**Application for Minor Amendments
to Reserved Matters Approval
For Building T5 2013/2481/P**

King's Cross Central General Partner Ltd
Aga Khan Foundation (United Kingdom)

December 2014

Drawing Title
General Arrangement
North Elevation

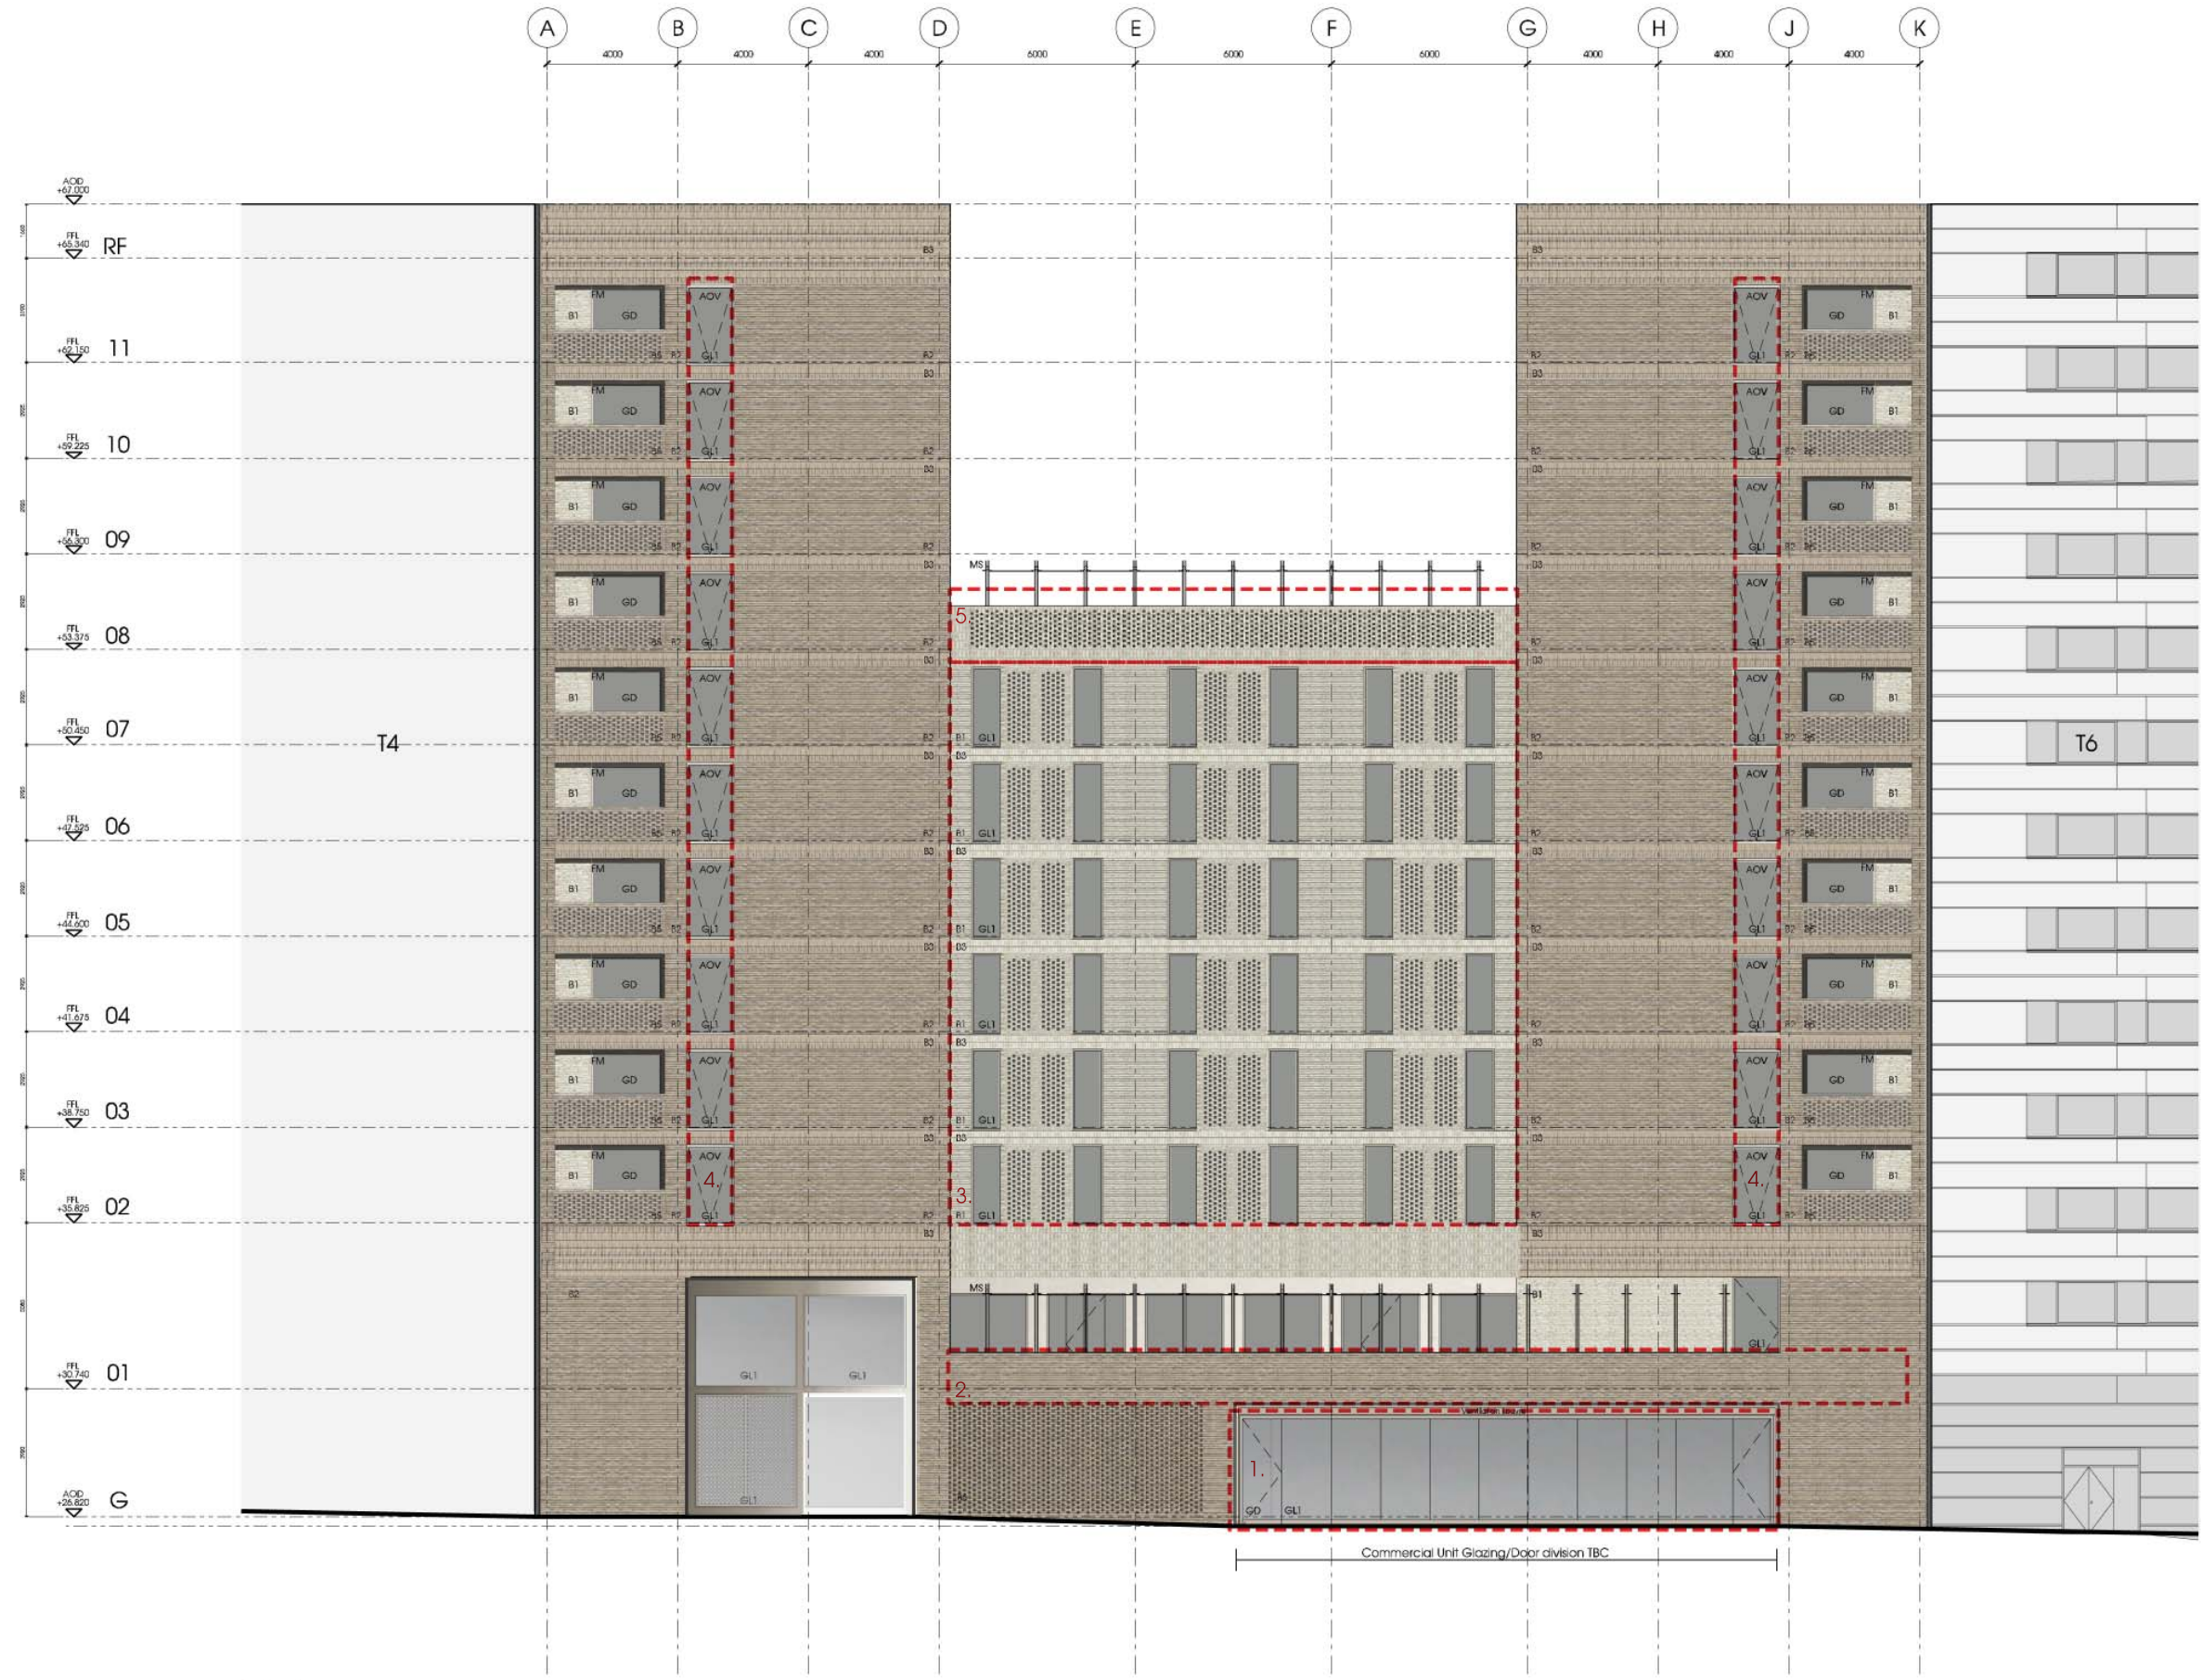
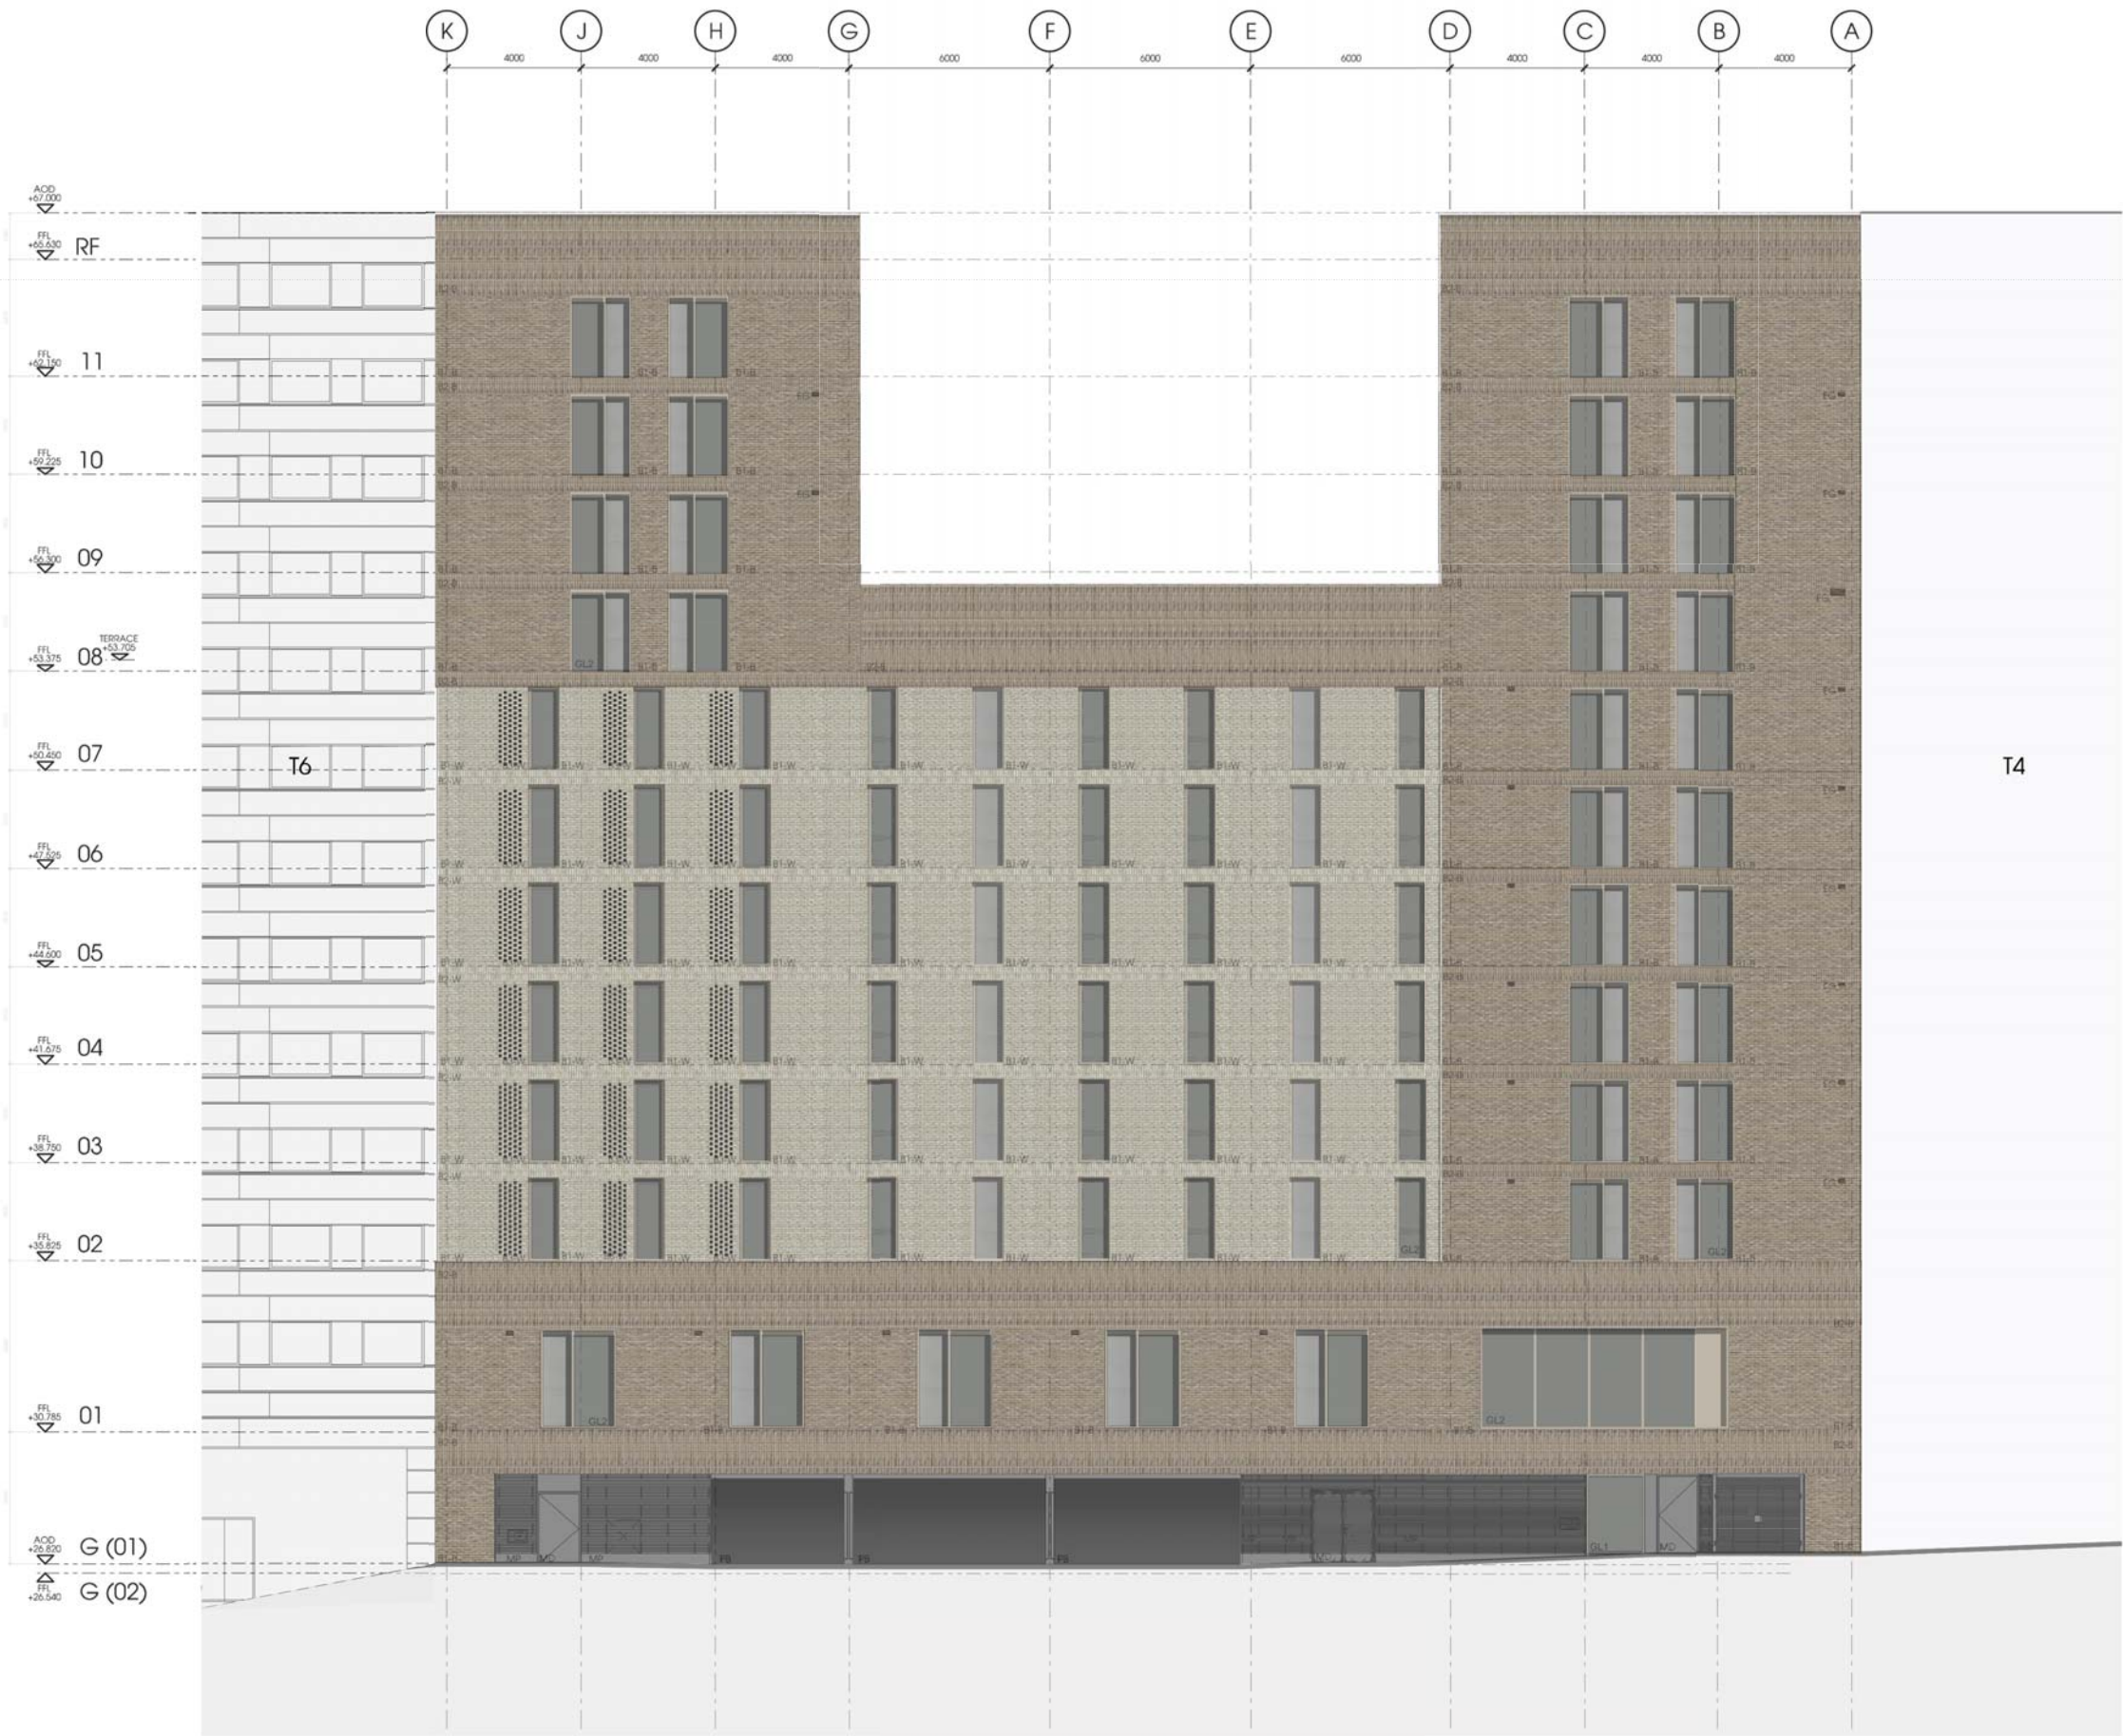
- Revisions Key
1. Metalwork, glazing and openings updated level 00, louvres replace solid cladding
 2. Soldier course brickwork added level 01
 3. Hit and miss brickwork removed and replaced with metal grill, glazing type updated level 01. Note all glazing set back.
 4. Glazing line to corridor and bedrooms, levels 02-07, set back
 5. Hit and miss brickwork removed and replaced with metal grill, glazing type to studio rooms levels 02-11 updated. Note all glazing set back.
 6. Soldier course brickwork added in place of blind hit and miss brickwork level 08
 7. Hit and miss brickwork removed and replaced with metal grill, glazing type to studio rooms levels 08-11 updated. Note all glazing set back.
 8. Glazing to west tower removed
 9. Glazing set back.

The design intent is for larger openings and varying detailing at ground floor level, articulating the space within. The arrangement of brickwork and metal cladding at ground floor level along the northern facade has been revised to add clarity to the buildings service areas, and integrate louvre grilles, dry risers, the bin store entrance, escape doors and the entrance to the substation within one clearly defined zone. The area has been further defined by the replacement of the varying materials at this level, as indicated on drawing 426 00_232 P0 with the introduction of a darker PPC colour to lock the arrangement as a 'cassette' into the

This is shown as amendment 1 on drawing 426 00_232 P0 submitted in section 2.1 for information and the revised proposal is submitted on drawing 426 00_232 P1 in section 2.2 for approval.

Additional bands of soldier coursing have been added at level 1 and 2. This amendment is consistent across all elevations to strengthen the relationship between the northern and southern elevations. This is shown as amendment 2 on drawing 426 00_232 P0 submitted for information, and on drawing 426 00_232 P1 submitted for approval.

To enhance the contrast between the lighter and darker areas of brickwork, further emphasising the concept of a 'carved' facade, an amendment is proposed to the glazing and surrounding brick treatment to the studio apartments situated behind the darker brick of the elevation, on both the eastern and western bookends and at first floor level. The glazing and hit and miss brickwork at each window opening is proposed to be replaced with a combination of stretcher bond brickwork and areas of lightweight extruded aluminium. This continues the concept of a punched facade, and the differentiation between the lighter and darker areas of carved volume and captured space. This is shown as amendments 3, 5, and 7 on drawing 426 00_232 P0 submitted for information, and the revised proposal is shown on drawing 426 00_232 P1 submitted for approval.

from the north with the light brickwork of the courtyard. This is shown as amendment 4 on drawing 426 00_232 P0 submitted for information, and the revised proposals are shown on drawing 426 00_232 P1 for information.

The band of blind 'hit and miss' brickwork located centrally at 8th floor level has been replaced by a deep band of soldier course brickwork, to reflect the soldier course banding at the top of the east and west towers, and also at first floor level. This is shown as amendment 6 on drawing 426 00_232 P0 submitted for information, and on drawing 42600_232 P1, for approval.

A line of glazing has been removed, to the internal corridor at levels 02-07 of the west tower, between the area of lighter brickwork and the windows to the studio flats in the western tower. The omission of this glazing is proposed to strengthen the form of the west tower by bringing a larger area of solid brickwork through from the upper floors to level 01. This is amendment 8 on drawing 426 00_232 P0 submitted for information, and on drawing 42600_232 P1, for approval.
